RE: TEDS Exception from Access Spacing for the Larson Subdivision, 2919 ½ B1/2 Road

DESIGN EXCEPTION #DE21-02

To: Mark Relph, Director of Public Works & Utilities
Thru: Tim Moore, Public Works Manager
Copy to: Dave Donohue, Development E.I.T.
From: Mike McDill, City Engineer
Date: August 2, 2002
RE: Exception from Access Spacing for the Larson Subdivision, 2919½ B1/2 Road

Encl: Preliminary Site Plan

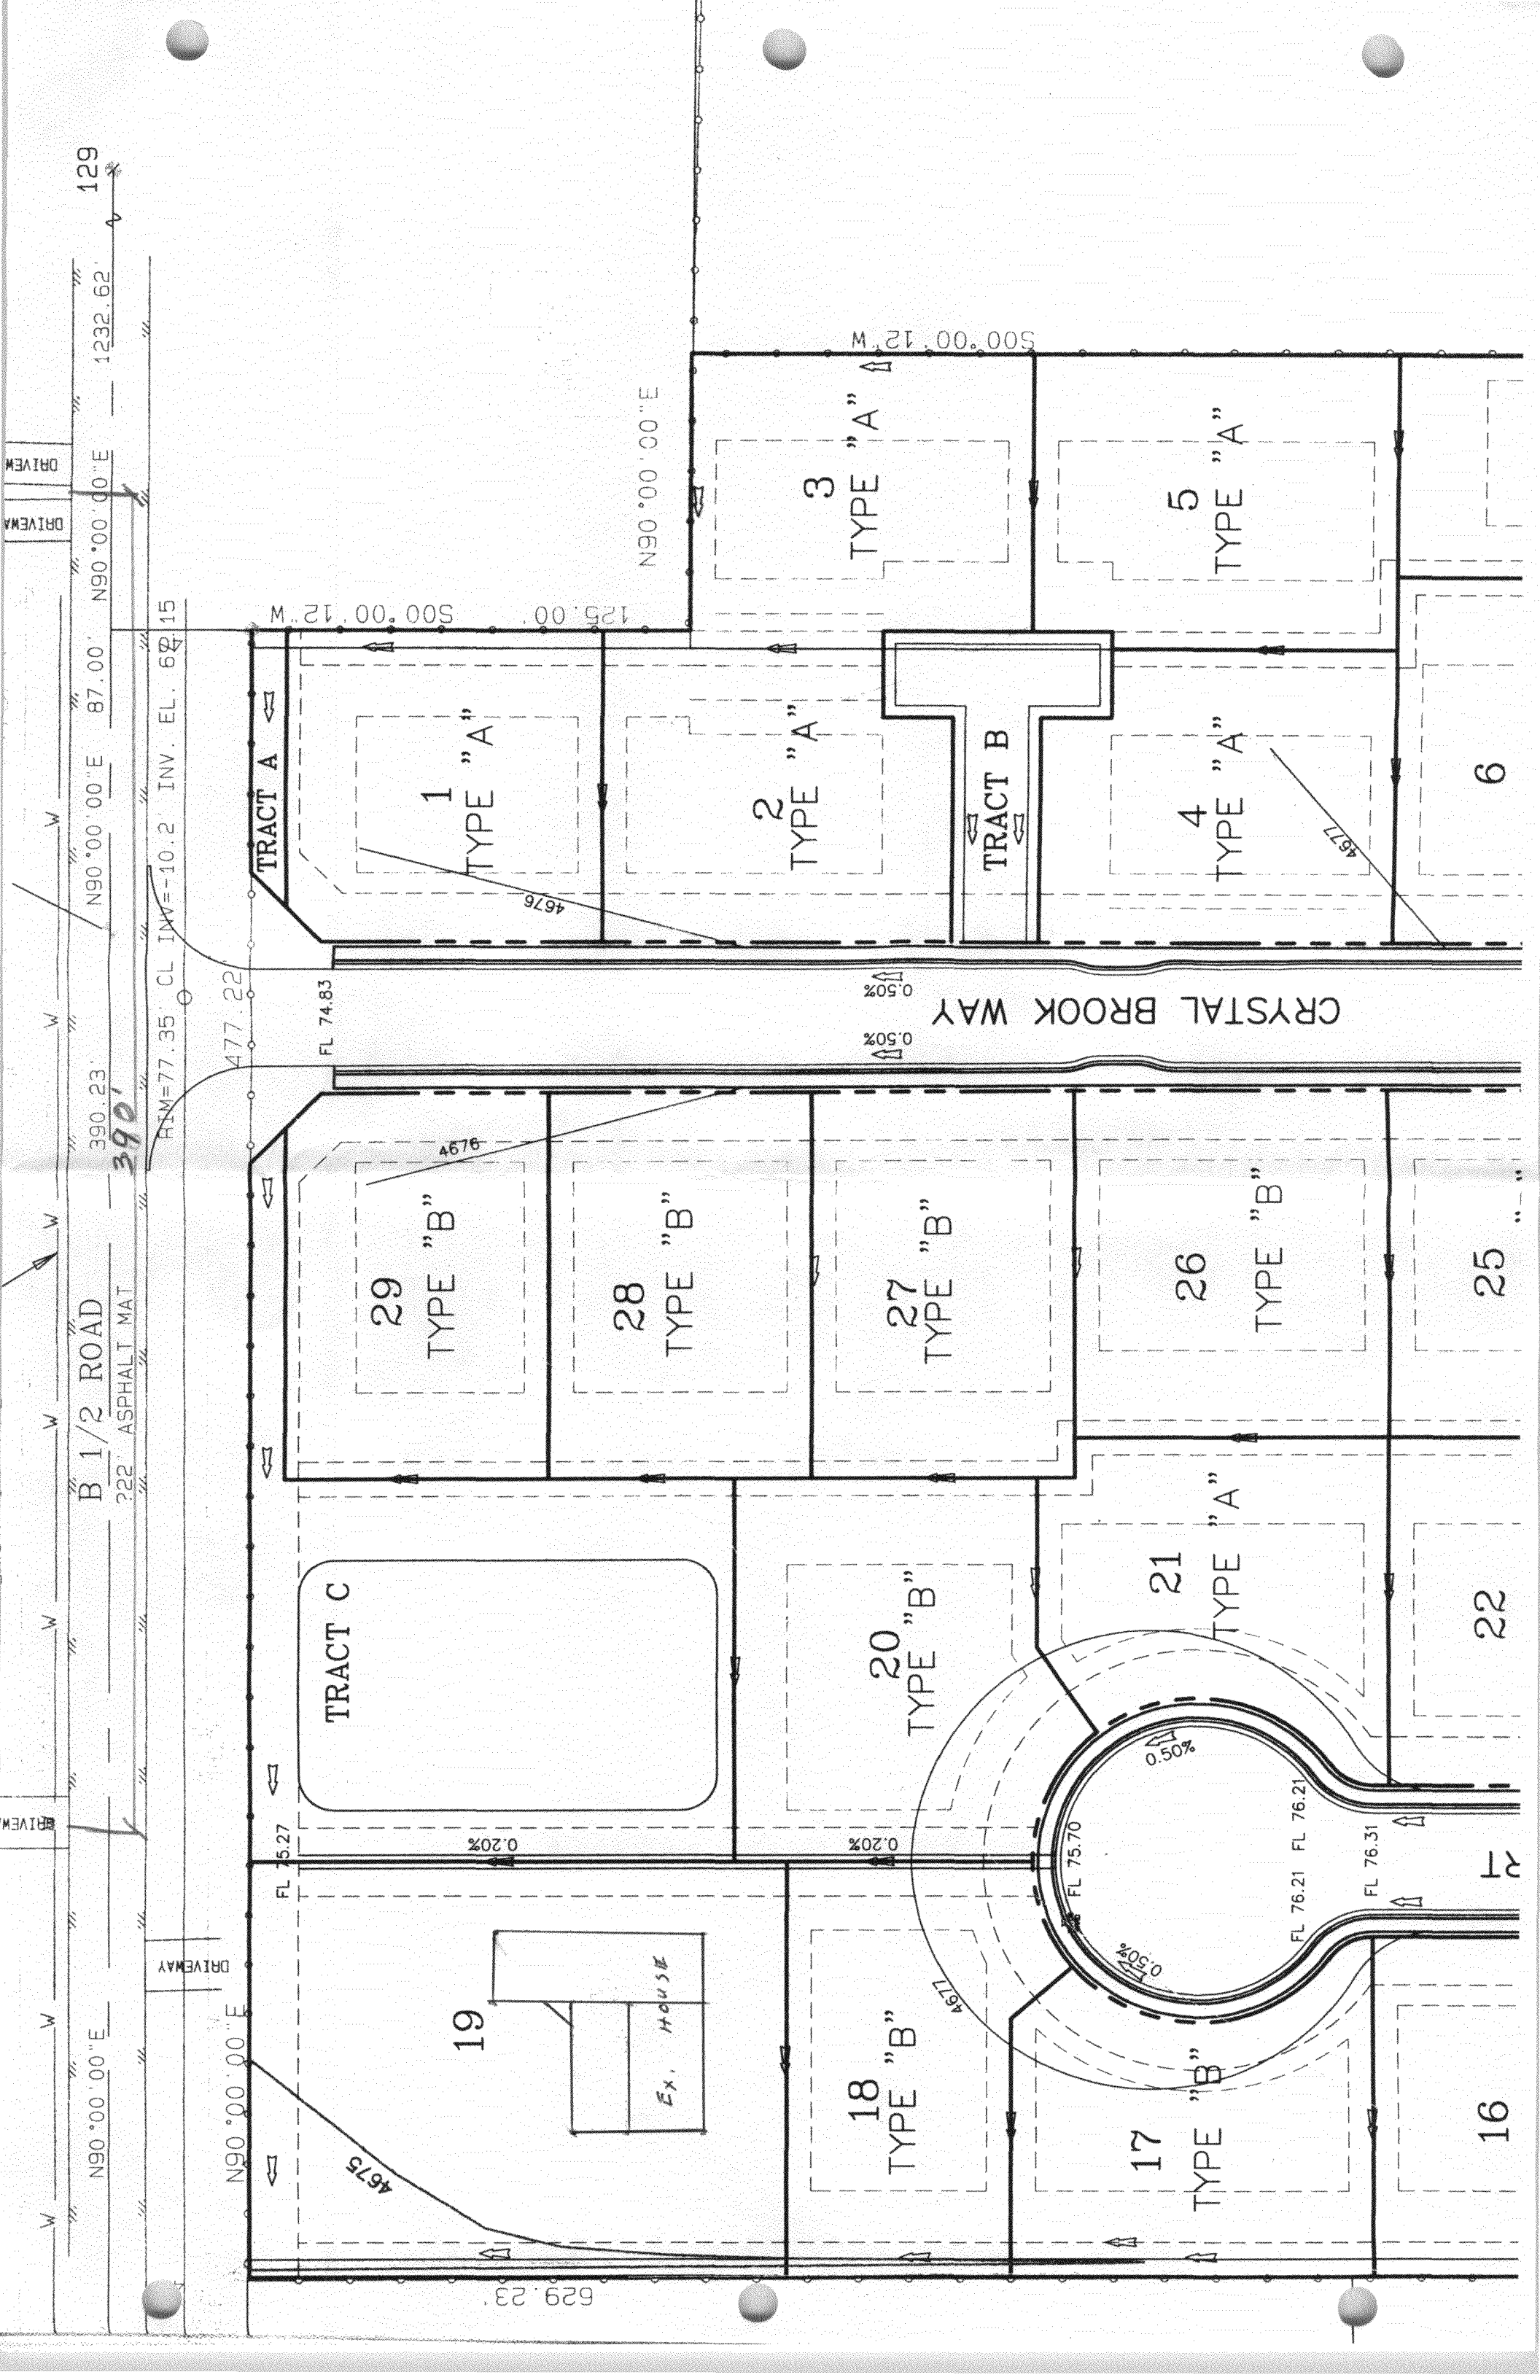
It appears to me that, by flipping the layout (to put the street access along the west side, opposite the existing drive, and the cul-de-sac along the east), they can meet their needs and comply with our standards. This would also allow the existing home at 2919 ½ B1/2 Road to access from the local street instead of the current plan to maintain the existing drive on B1/2 Road.

I am not in favor of compromising the TEDS guidance in this issue. Possible solutions to the situation are relocating the site's access to Kameron, or relocating nearby "conflicting" accesses to a shared point opposite Crystal Brook. Furthermore, I feel the access spacing issue is not a major impediment to this development's current design, and that it's present predicament is more the result of a disregard to the standards than a design limitation of the site.

This site's access point was designed without respect to the new TEDS guidelines regarding access spacing for this class of roadway (minor arterial). Review of the plan set, and ensuing conversations with the project designer have not shown limitations to the site that prevent TEDS compliance in the matter.

I don't feel that these arguments, as expressed, supercede the need for safe, efficient B ½ flow. The plans are in conflict with a standard in effect for nearly a year, with no apparent effort has been made to address the guidance since the issue was raised in Impact comments presented in March of 2002. Additionally, the quality of life for the Lot 19 home will as likely be compromised by future B ½ Rd traffic as it will by being adjacent to the site's access.
